Approach Permit & 911 Address Form

HIGHWAY DEPT. USE ONLY	
Permit #:	67-09-18
911 Address:

Applicant/ Property Owner: Glen Ullin Energy Center, LLC		Current Mailing Address: 30 W Superior St, Duluth, MN 55802					
E-mail Address: jhollingsworth@allete.com		Daytime Phone or Cell #: 218-355-3249					
Lot:	Block:	Subdivision: Approach #5 Coordinates: 46.974491, -101.844697	<table border="1"> <tr> <td>Quarter: NE 1/4</td> <td>Section: 1</td> <td>Twp: 140</td> <td>Rge: 89</td> </tr> </table>	Quarter: NE 1/4	Section: 1	Twp: 140	Rge: 89
Quarter: NE 1/4	Section: 1	Twp: 140	Rge: 89

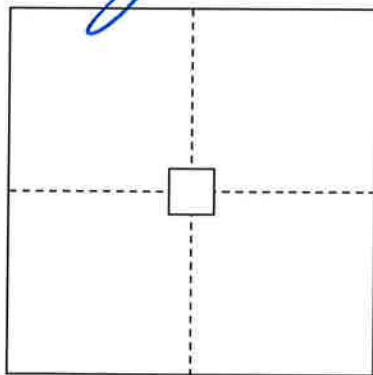
Culvert Comments: *At time of construction place a minimum of 1 foot fill over pipe and increase culvert length to correspond with desired approach top over 20 feet.*

Approach Comments: (Sight Distance? Problems? Etc.) *At time of construction place 4 inches gravel on approach.*

Inslope work required for 8:1 slopes
